SUNDRY NOTICES AND REPORTS ON WELLS

SJ 29-5 Unit #32A

The subject well's APD has not expired and plans are now to include the Dakota interval when drilling. This sundry is to notify the BLM that the well's name will be changed to "S.J. 29-5 #32M" and all subsequent and completion reports will reflect the new name.

WELL LOCATION AND ACREAGE DEDICATION PLAT

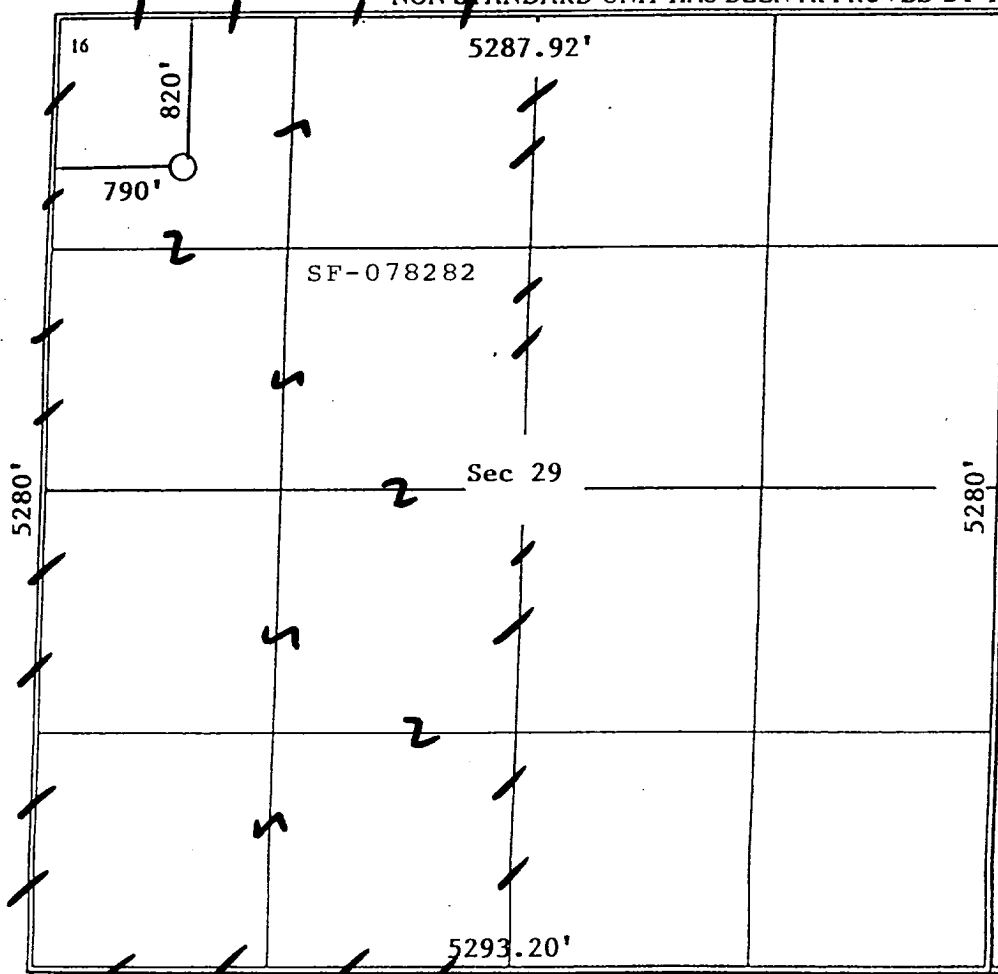
Also included with this sundry is the acreage dedication plats for both the Mesaverde and Dakota reflecting the new well name and a new drilling prognosis. The original APD's Surface Use Plan will still apply.
